Traffic Management Plan AC Black Elementary School

September 23, 2022

Traffic Management Plan

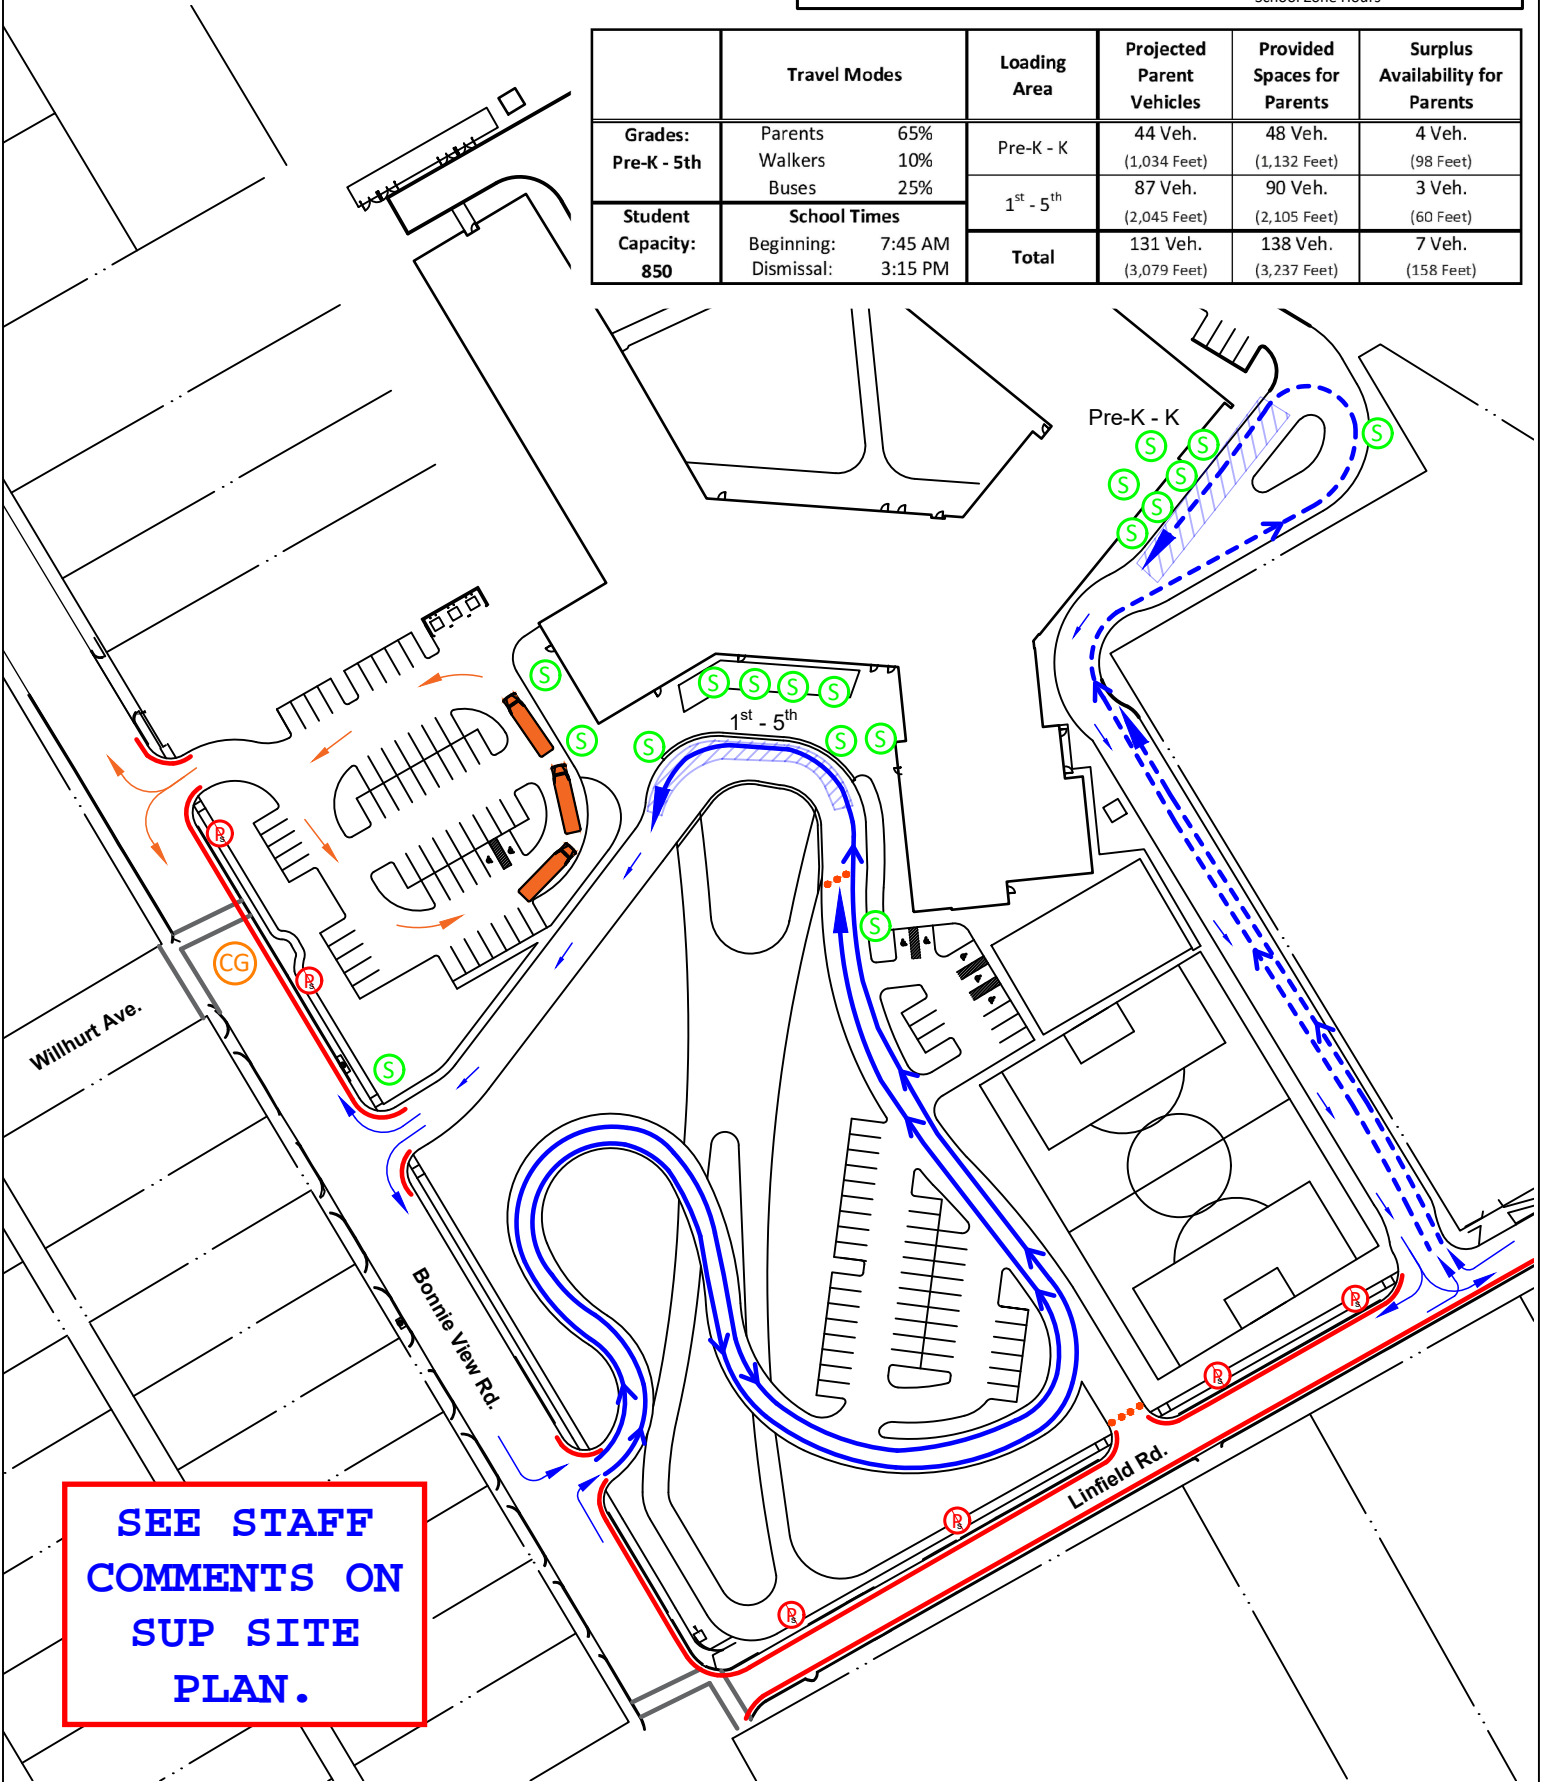
SEE STAFF
COMMENTS ON
SUP SITE
PLAN.
